NLR Planning Commission
February 9, 2016
Agenda Meeting / Public Hearing 4:45 PM

A. SD2015-20 Freeman's Addition, Lot 17R (Site Plan Review of a tire store located 3900 Camp Robinson Rd

CASE: Conditional Use #CU2016-4

PROJECT NO.: C1.0

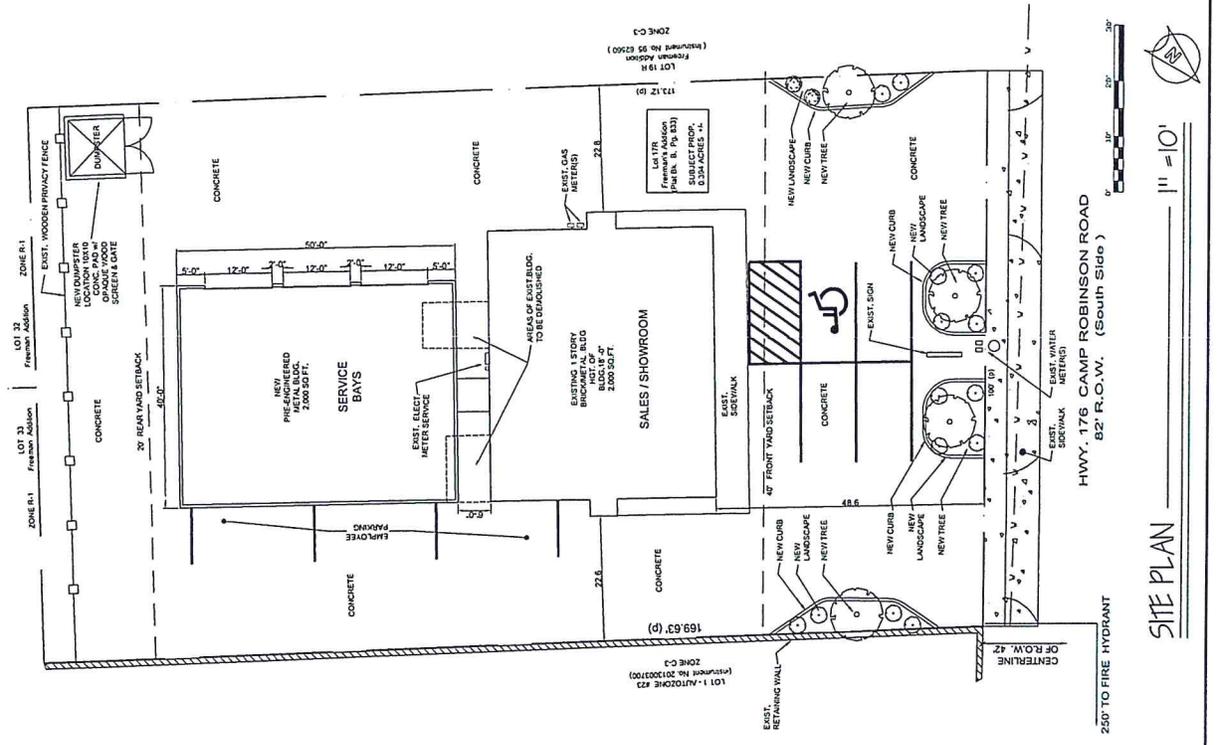
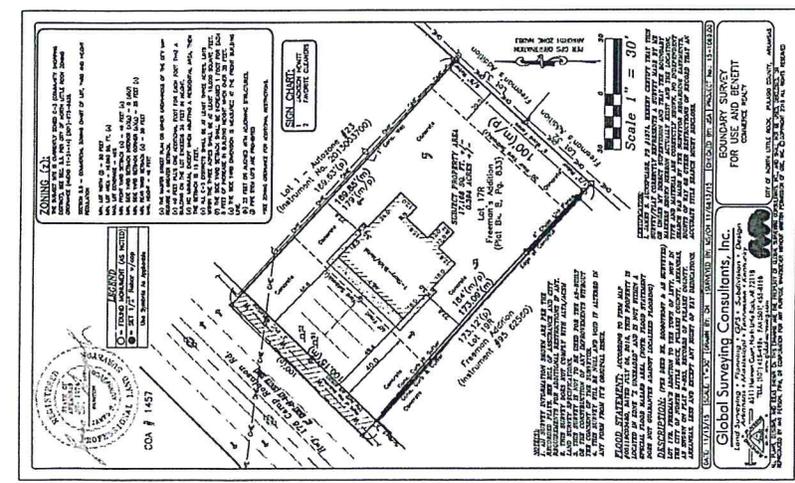
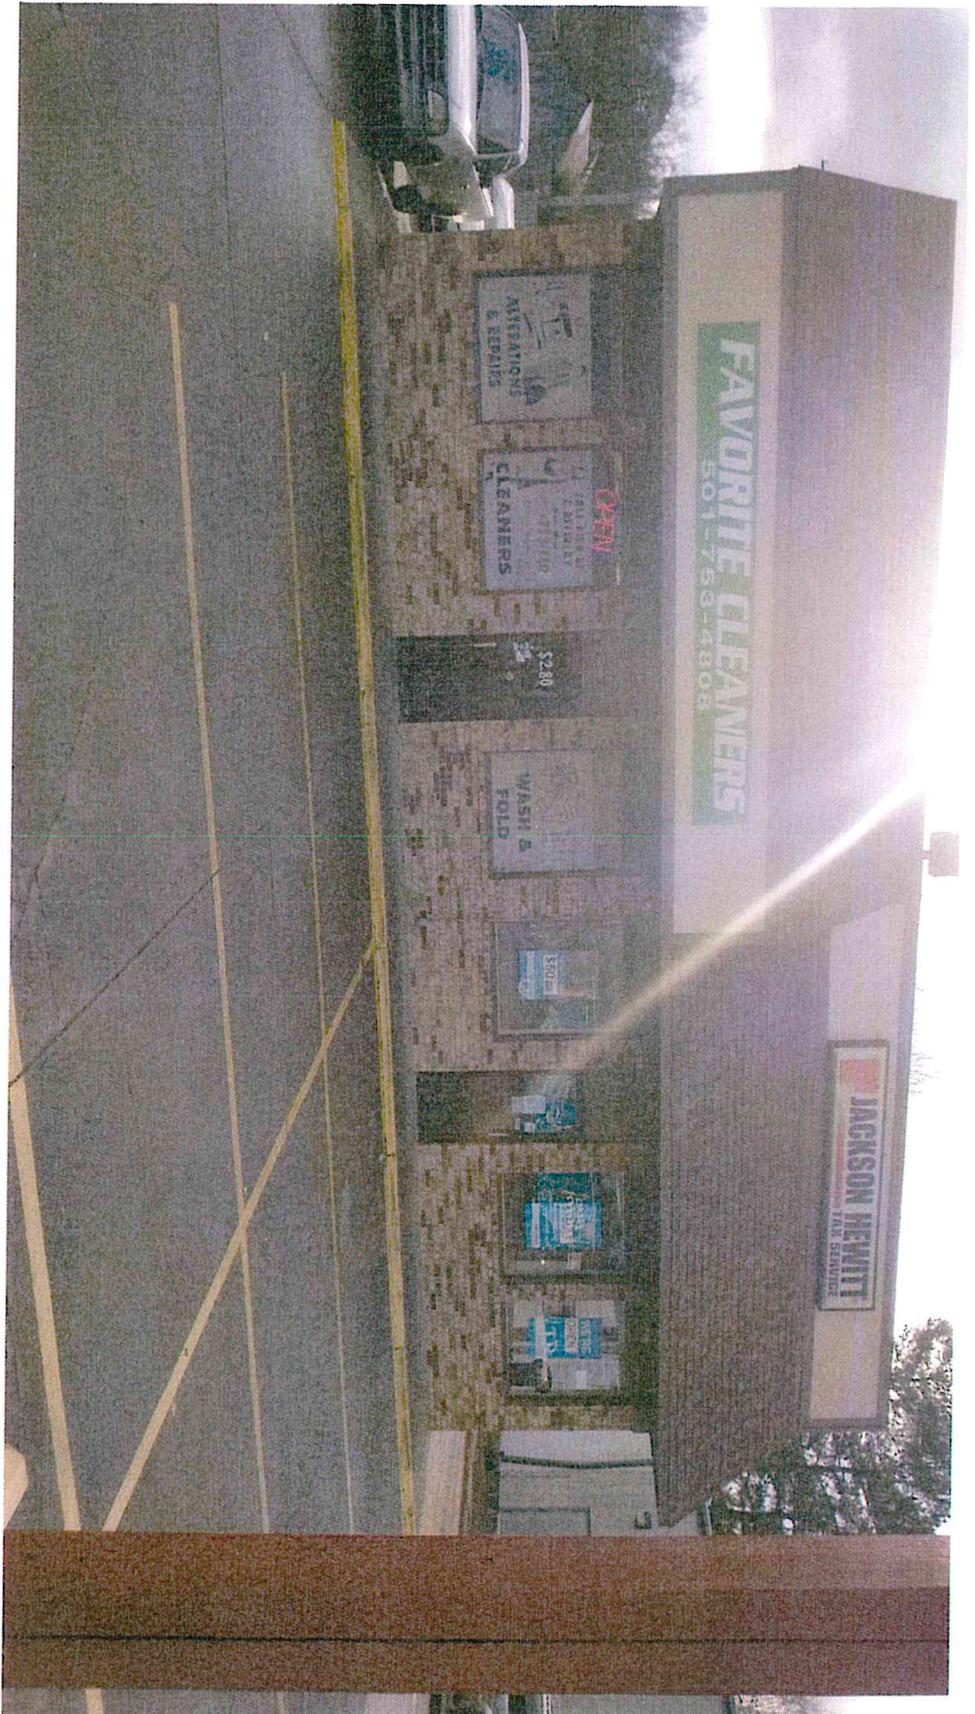
- 1. Permit requirements/approvals before a building permit will be issued:**
 - a. Provide approved City Council ordinance allowing a tire store at this location.

- c. All driveways are to be concrete within the ROW.
 - d. Show first floor building elevation.
 - e. Show sewer lines and other existing and proposed utilities.

- 3. Meet the requirements of Community Planning, including:**
 - a. Provide the standard requirements of Zoning and Development Regulations.
 - b. Dumpster to have masonry screening.

- a. Provide 6' sidewalk directly behind curb and gutter.
 - b. Leave sidewalk and driveway apron and remove any concrete in ROW and replace with landscaped area.

- b. Provide automated underground irrigation to all required trees and shrubs.
 - c. Provide 2 street trees 40' on center.
 - d. Provide 2 parking lot shade trees.

- e. Provide 6 foot front yard landscape strip between property line and paving.
 - f. Waive 4 foot side yard landscape strip between property line and paving.

- b. No pole sign permitted. No electronic changeable copy sign permitted.
- 7. Meet the requirements of the Fire Marshal, including:**
 - a. Provide an approved fire protection plan.

- b. Meet Fire Marshal's requirements on fire hydrant location.
 - c. Fire hydrants to be within 400 feet of all areas of building.
- 8. Meet the requirements of CAW, including:**

🕒 SITE PLAN
SCALE: 1" = 30'-0"

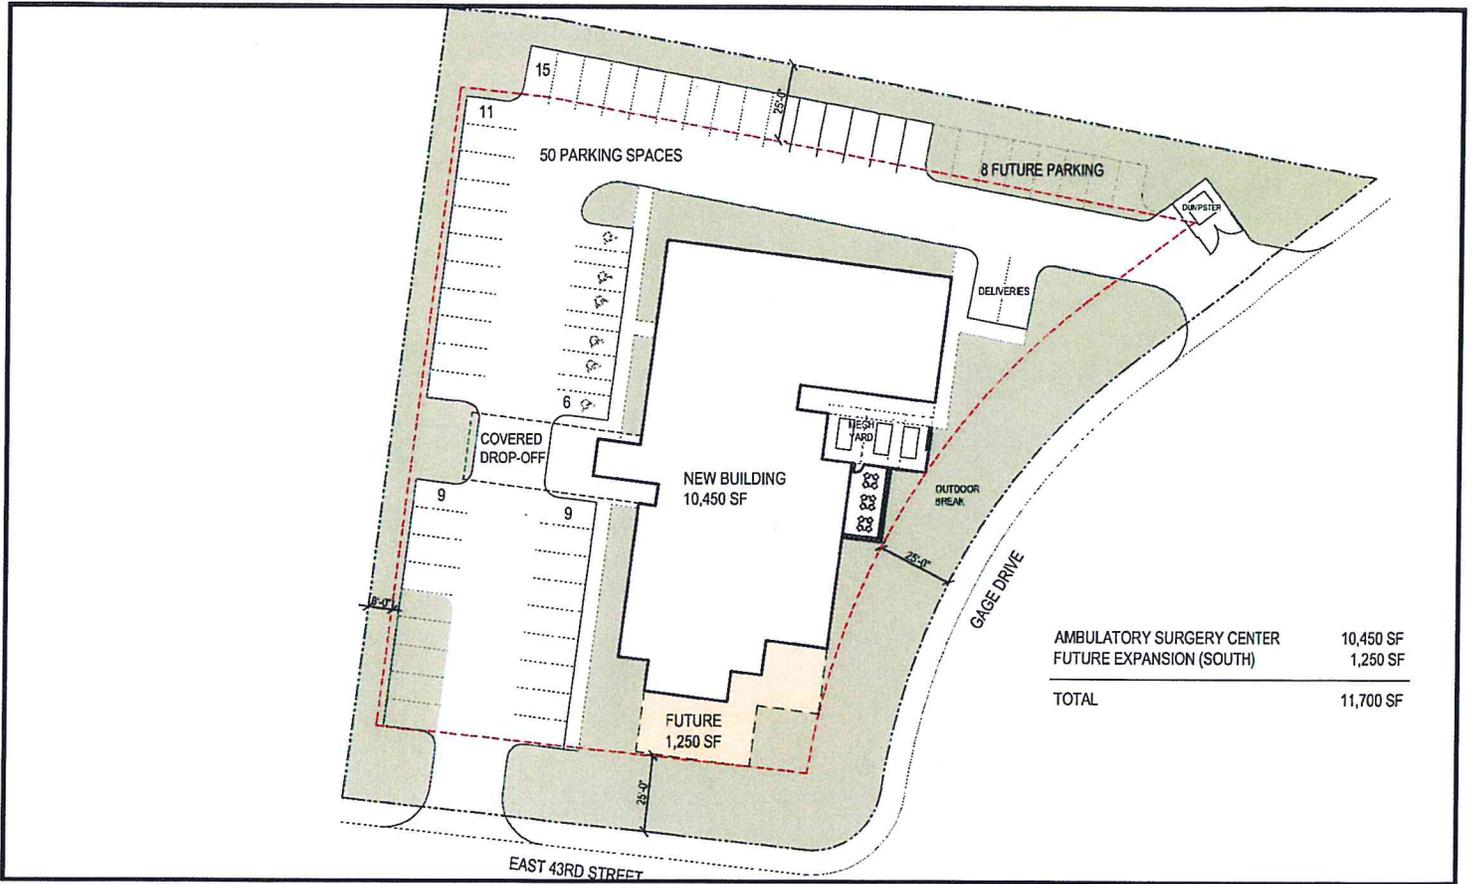
SUMMARY: Applicant wants to rezone property to C-2 in order to allow a surgical clinic.

STAFF RECOMMENDATION: Approve
